**From:** Brian Kappen <bkappen@enviroforensics.com>  
**Sent:** Wednesday, April 7, 2021 10:50 AM  
**To:** Beggs, Tauren R - DNR  
**Cc:** Ross Niemi; Richard Carey; Robert Fedorchak  
**Subject:** RE: Follow up Needed for Vapor Assessment and Mitigation, Cobblestone Hotel & Suites, 1407 16th Street, Two Rivers  
**Attachments:** Two Rivers Hotel Group\_WDNR Response Letter\_Final.pdf

**From:** Beggs, Tauren R - DNR [<mailto:Tauren.Beggs@wisconsin.gov>]  
**Sent:** Wednesday, November 11, 2020 11:26 AM  
**To:** Ross Niemi <[rniemi@nesco.com](mailto:rniemi@nesco.com)>; Richard Carey <[rcarey@mwcorp.com](mailto:rcarey@mwcorp.com)>; Robert Fedorchak <[rfedorchak@enviroforensics.com](mailto:rfedorchak@enviroforensics.com)>; Brian Kappen <[bkappen@enviroforensics.com](mailto:bkappen@enviroforensics.com)>; 'sschmutzer@brimarkbuilders.com' <[sschmutzer@brimarkbuilders.com](mailto:sschmutzer@brimarkbuilders.com)>  
**Cc:** Schultz, Josie M - DNR <[josie.schultz@wisconsin.gov](mailto:josie.schultz@wisconsin.gov)>; Borski, Jennifer - DNR <[Jennifer.Borski@wisconsin.gov](mailto:Jennifer.Borski@wisconsin.gov)>  
**Subject:** Follow up Needed for Vapor Assessment and Mitigation, Cobblestone

Photograph 5: Pipe penetration through west wall of elevator pit

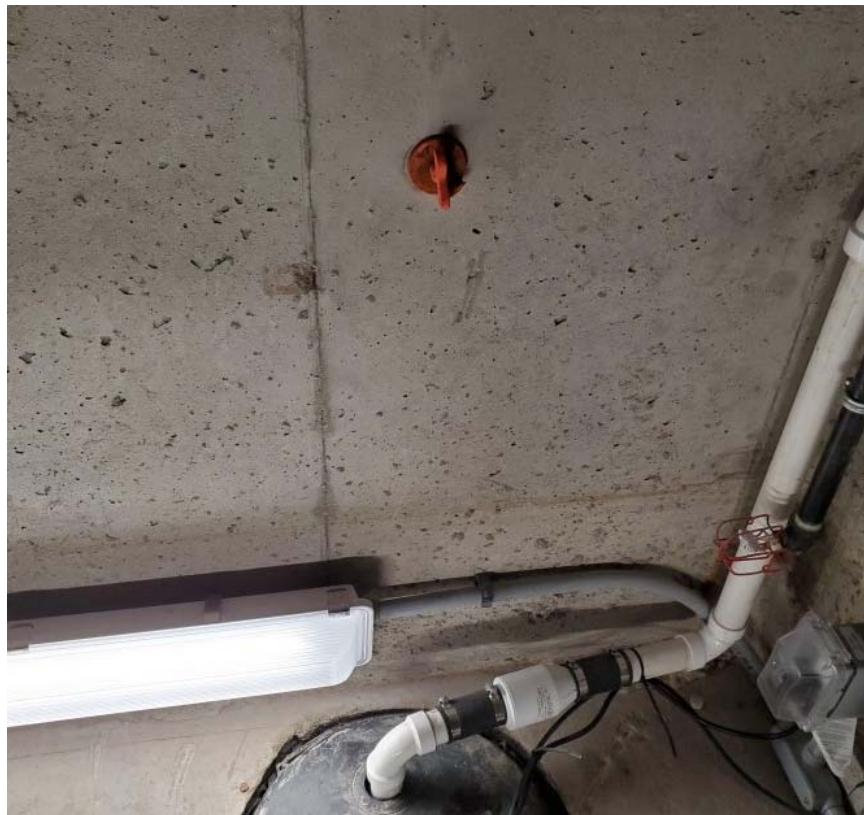
- A plastic pipe penetrates the west wall of the pit, approximately four feet above the floor. The pipe appears to extend through the entire thickness of the wall and into the backfill. A membrane on the outside wall was visible through the pipe; however, it did not appear to completely cover the pipe opening. The pipe was plugged with an expandable plug

designed for monitoring wells after the passive indoor air sample was collected (see Photographs 5 and 6).
